RE: Planning Board Meeting on 5 Feb 2009
CLAREMONT AIS SUBDIVISION
PHASES 4+5
MAJOR MODIFICATION TO
CONDITIONAL USE PERMIT
1001 HOMESTEAD ROAD
CARRBORO NORTH CAROLINA

Date: February 19, 2009
 To: James Thomas, Zoning Development Specialist
 Cc: Roy Williford, Planning Director
 Patricia McGuire, Planning Administrator
 Marty Roupe, Development Review Administrator
 From: R. Dodd Environmental Planner
 Subject: Claremont II Public Hearing response

To: James Thomas, Zoning Specialist
 Cc: Steve Stewart, Town Manager
 Roy Williford, Planning Director
 Patricia McGuire, Planning Administrator
 From: Adena Messinger, Transportation Planner
 Randy Dodd, Environmental Planner
 Re: Trails and Greenway Questions from the Claremont II Public Hearing
 Date: February 18, 2009

RE: Claremont Phase 4 and 5
Response to Matters Discuss at January 27, 2009 Public Hearing (Two Attachments)

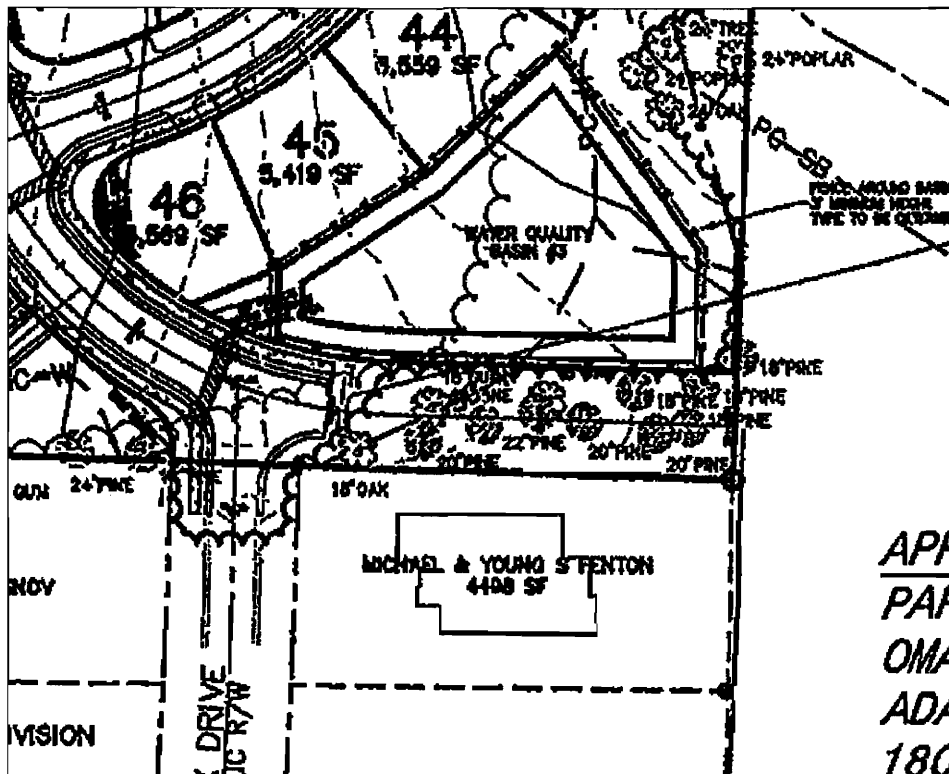
I have been reviewing the plans submitted by the developer (Zinn) and have major concerns about the placement of the Water Quality Basin #3 as shown below:

When we purchased the land in the Wexford subdivision we fully expected that the Hogan property would be developed at a future time. We built our home with expectation that we would have neighbors and that would be a good thing. What we did not expect however, was that instead of a home being built next to us in Claremont, we are told that a huge concrete drainage basin will be constructed to capture funnel led runoff water from the subdivision. We never in a million years expected that such a large and unsightly concrete structure would be built right adjacent to our home, running the entire 200 feet length of the property. Basically, the dirty runoff water from Claremont is being funneled directly to our home. This is neither right nor acceptable.

We are deeply worried that this structure and method of handling runoff damages our expectation to safe and clean surroundings, and will reduce and harm the value of our property and the enjoyment and quality of life we believe is the right of every citizen in Carrboro. We are not objecting to the Claremont development, only to the placement of Water Quality Basin #3. We are not against economic development per se, but strongly object to the placement of such large drainage structures in close proximity to our home.

Think about this: would you like to have such a huge concrete drainage basin built right next to your home? Would you like to have your neighbor's runoff water flowing next to your home? I do not believe you would like it, nor should you. These unsightly structures should be placed away from habitable areas. Alternately, some other method distributing runoff should be found that does not materially damage the property of the citizens of Carrboro.
